GLOBAL SAFETY FIELD INVESTIGATIONS
DCS6518
URGENT - DISTRIBUTE IMMEDIATELY

Subject: N222390620 - Service Update
Engine Wiring Harness

Models: 2022 – 2023 Cadillac CT4

N222390620 Engine Wiring Harness

6305393

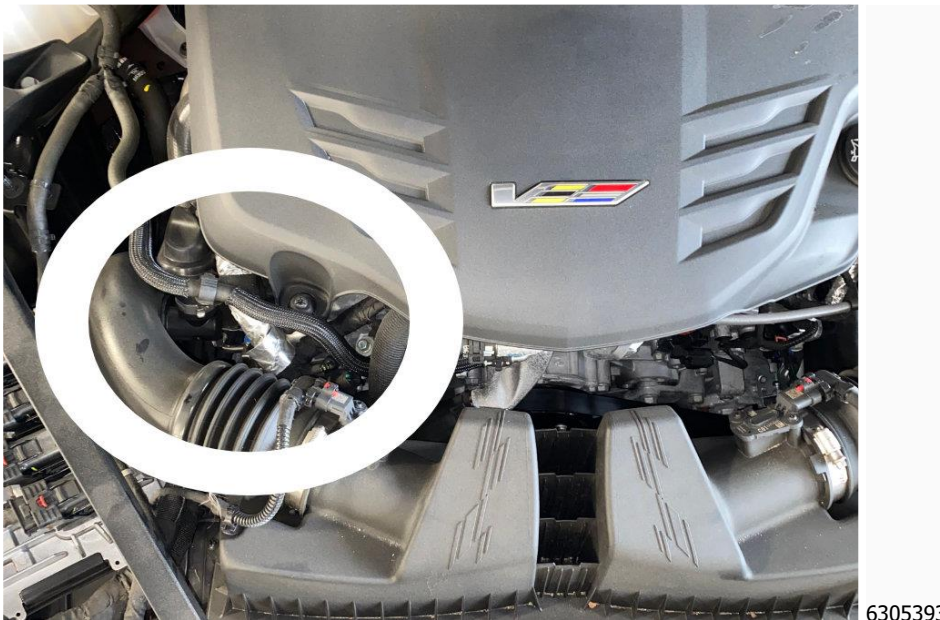
Condition	Certain 2022 - 2023 model year Cadillac CT4 vehicles may have an Engine Wiring Harness breakout branch for the power steering that is not properly secured at the front of dash near the airbox.
Correction	Dealers are to inspect and if necessary, secure the wiring harness branch clip.

1. Open the hood and locate the area highlighted above.

6305402

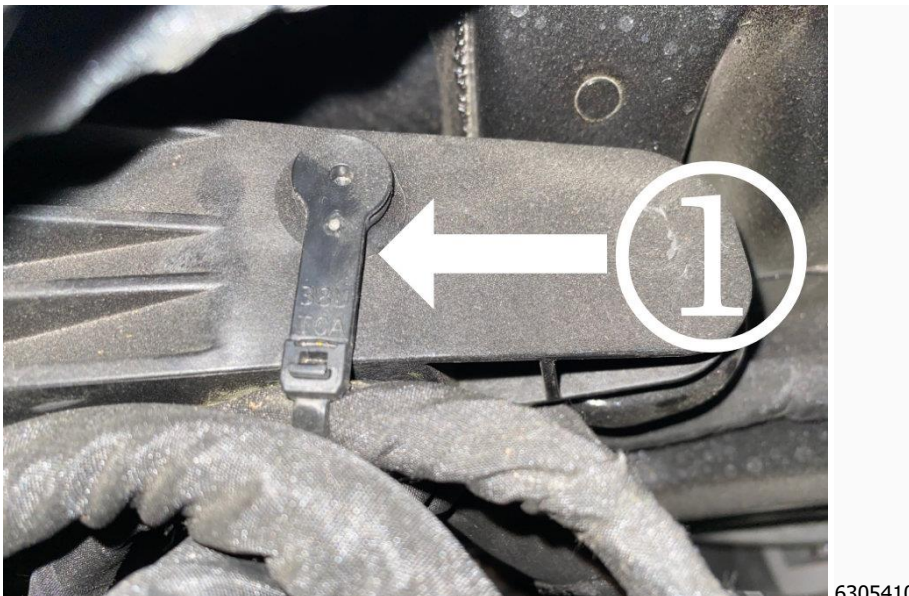
2. Locate area 1.
3. Locate the wire harness retainer (2) within area 1.

6305410

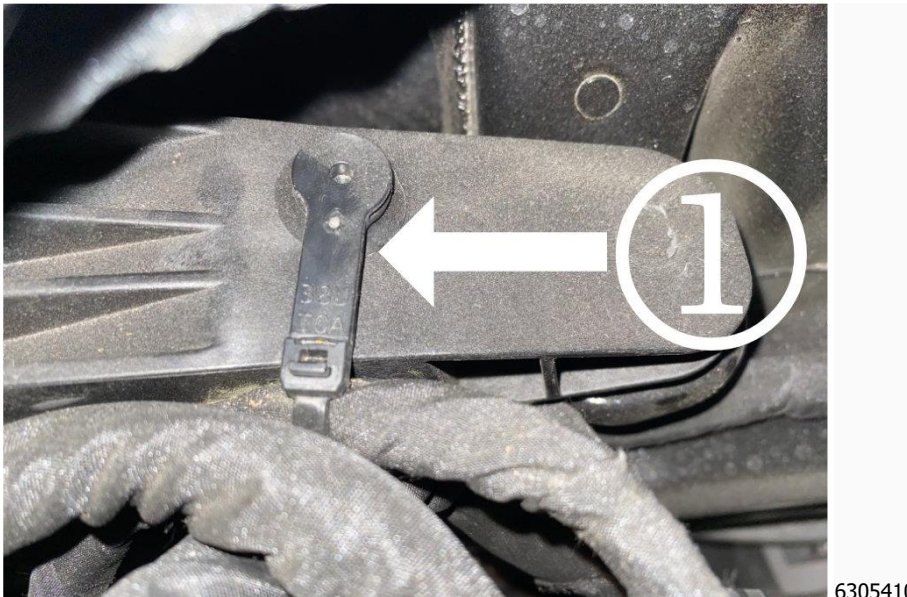
4. Verify the wire harness retainer (1) is properly seated, as shown above.
 - If the wire harness retainer (1) is properly seated, no further action is required. Proceed to step 7.
 - If the wire harness retainer (1) is not properly seated, proceed to step 5.

Note: An improperly seated wire harness retainer can cause the wire harness to rub on the Accessory Drive Primary Belt. Ensure the wire harness is inspected along the entire section that could come in contact with the Accessory Drive Primary Belt.

5. Inspect the wiring harness for damage.
 - If no damage is found, proceed to step 6.
 - If any damage is found, repair the wire harness. Refer to *Wire to Wire Repair* in SI. Proceed to step 6.

6. Properly install the wire harness retainer (1), as shown above.
7. Close the hood.
